## CITY OF ALBUQUERQUE

Re: 1315 Mountain Rd. NW Request for Certificate of Occupancy - Permanent Hydrology Final Inspection –Not Approved Grading and Drainage Plan Stamp Date: 4/2/19 Certification dated: 9/1/20 Drainage File: J13D210

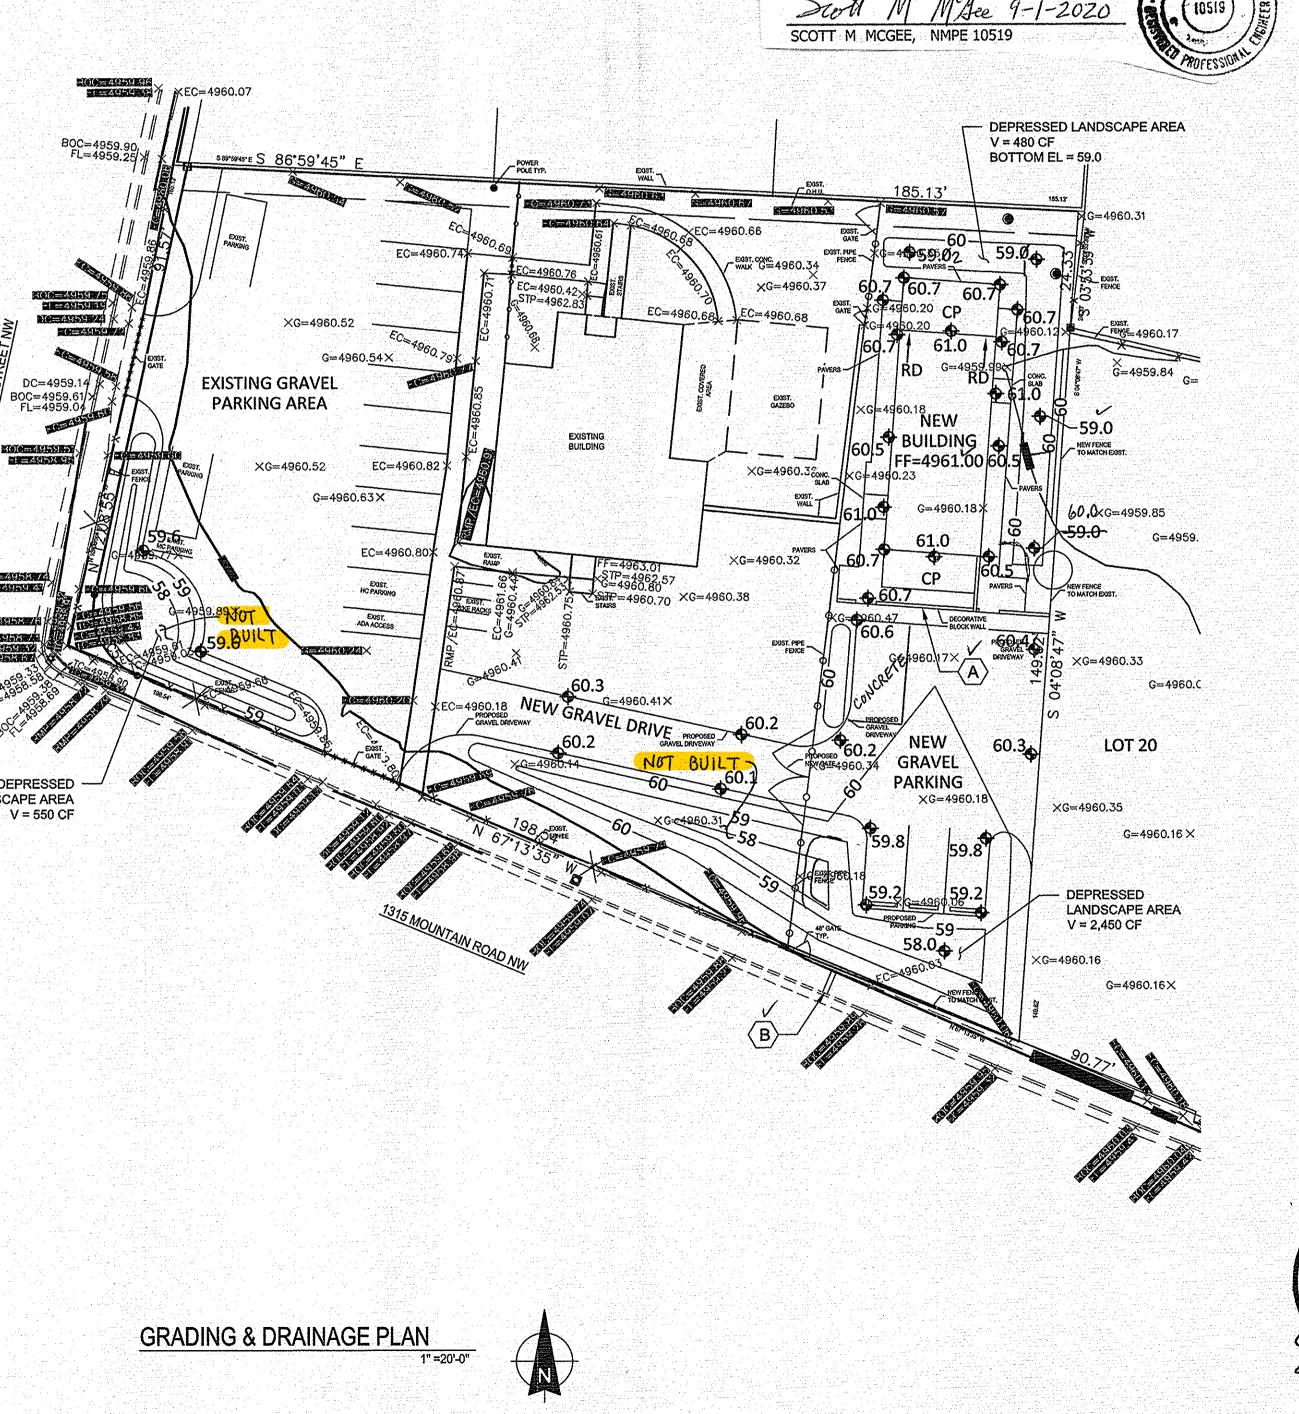
- PO Box 1293 Based on an inspection on 9/11/20 this certification cannot be approved for Permanent Certificate of Occupancy by Hydrology until the following issues are corrected:
- Albuquerque1. The first flush ponds shown on the plans were not constructed. These ponds need to be<br/>constructed or if you intend on using payment-in-lieu then you provide a receipt showing that<br/>this payment was made. Payment-in-lieu for this site would be calculated at \$8/CF which at<br/>4,790 CF would be 8 x 4,790=\$38,320.00
